Subject: Core Operating Limits Report – Fuel Cycle 27

Palisades Nuclear Plant
Docket 50-255
Renewed Facility Operating License No. DPR-20

Palisades Nuclear Plant Core Operating Limits Report

Revision 20

Figure 2.2-1 Regulating Rod Group Position Limits

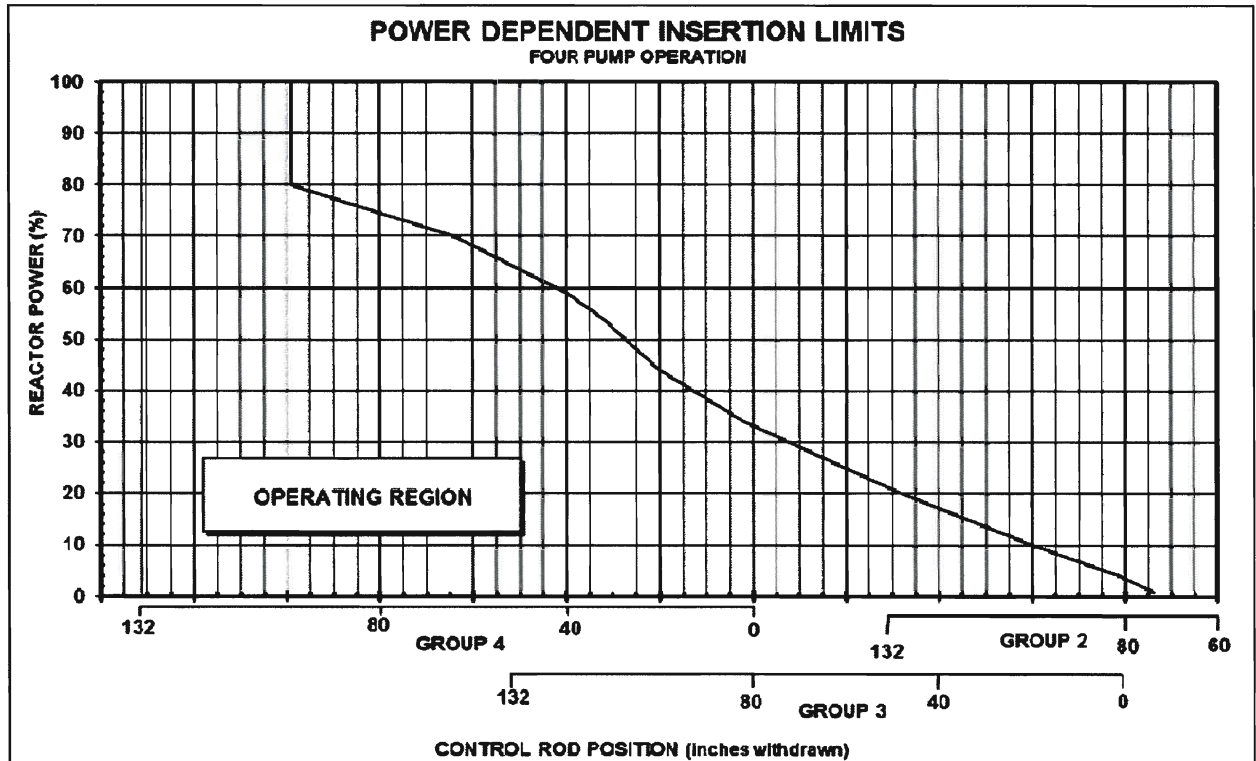
Missing information is restored to Figure 2.2-1, "Regulating Rod Group Position Limits," per CR-PLP-2017-05111 and DRN-17-00721.
